Work Order ID 102956

Item Name: Crosstube Fwd High

DRAWING NO. D212-664-141		TITLE XTUBE ASSY (205/212/412 HI FWD)		REV. D		DART AEROSPACE LTD ENGINEERING ORDER		D.E.O. NO. D212-664-141-D-1		SHEET NO. SHEET 1 OF 2		SCALE NTS	
DRAWN		CHECKED		MFG. APPR.		APPROVED		DE APPR.					
DATE 11.04.07		DATE 11.07.11		DATE 11.04.12		DATE 11/04/12		DATE 11.04.12

PURPOSE:
ADD AN INSPECTION WINDOW TO UNDERSIDE OF CROSSTUBE.

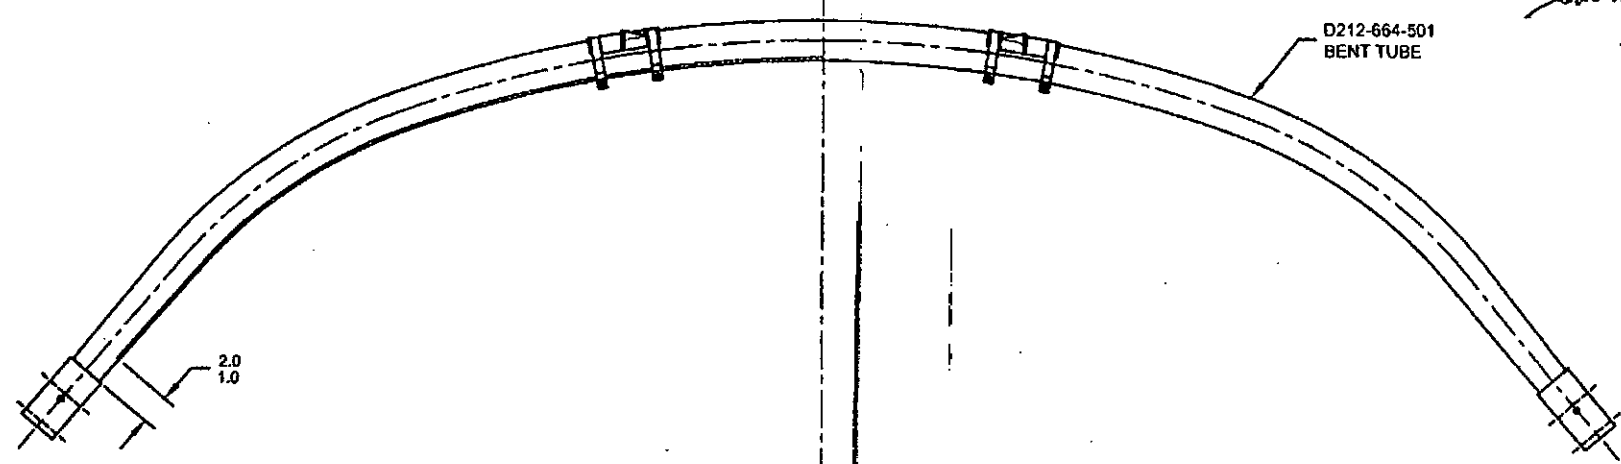
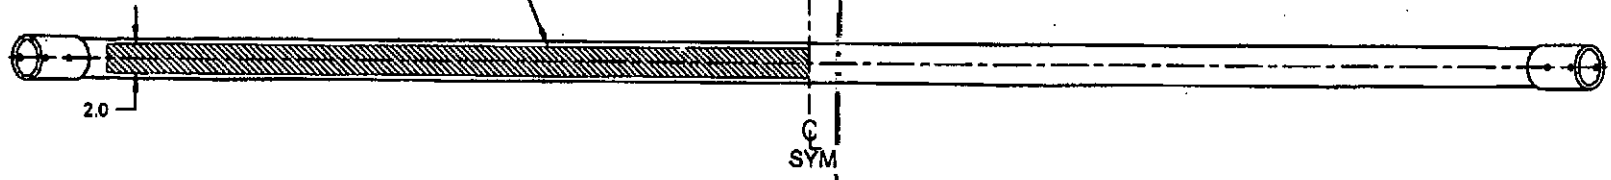
NOTES 2 OF SHEET 1 IS AMENDED AS FOLLOWS:

- 2) FINISH: CHEMICAL CONVERSION COAT PER DART QSI 005 4.1
PRIME INSIDE AND OUTSIDE PER DART QSI 005 4.2
MASK UNDERSIDE OF CROSSTUBE AS SHOWN (HATCHED AREA) AND
PAINT OUTSIDE PER DART QSI 005 4.2
REMOVE MASKING AND APPLY CLEAR COAT

MASK AREA PRIOR TO PAINTING.
REMOVE MASKING AFTER PAINT
AND APPLY CLEAR COAT
